## India Comments on Glare given to oncoming vehicles by Motorcycles DRLs at Night

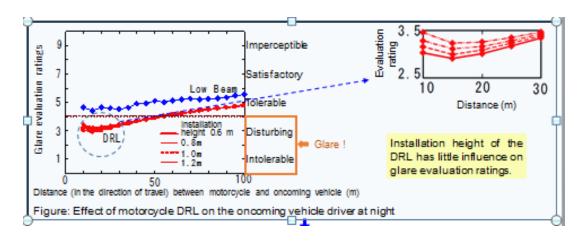
Japan has assumed Driver's adaptation luminance ( $cd/m^2$ ) to be 0.1  $cd/m^2$ . However, on the illuminated roads, the value is more than 100  $cd/m^2$  (see attached R-97-36-Safety effects of DRLs, Publication No. FHWA-HRT-08-029).

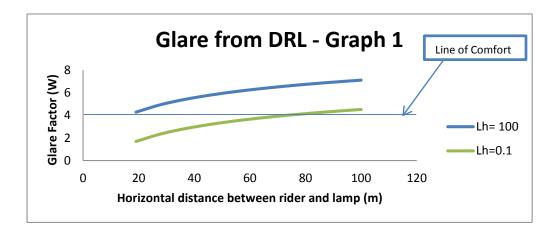
Change in  $L_h$  has significant impact on the result outcomes, to bring out that changes, India has done some numerical analysis keeping road illuminance as 100 and 0.1 cd/m<sup>2</sup> respectively. The values are well within the comfortable limits for  $L_h = 100 \text{ cd/m}^2$ .

In light of Graph 1 above, India requests Japan to clarify how  $L_h$  value of 0.1 cd/m<sup>2</sup> is considered?  $L_h$  value of 0.1 may be true for the specific country but may not be true for all other countries.

However, to address Japanese concerns of glare from DRL, India suggests a candela cutoff above which DRL would be conceived to be causing glare. The value may be mutually decided upon.
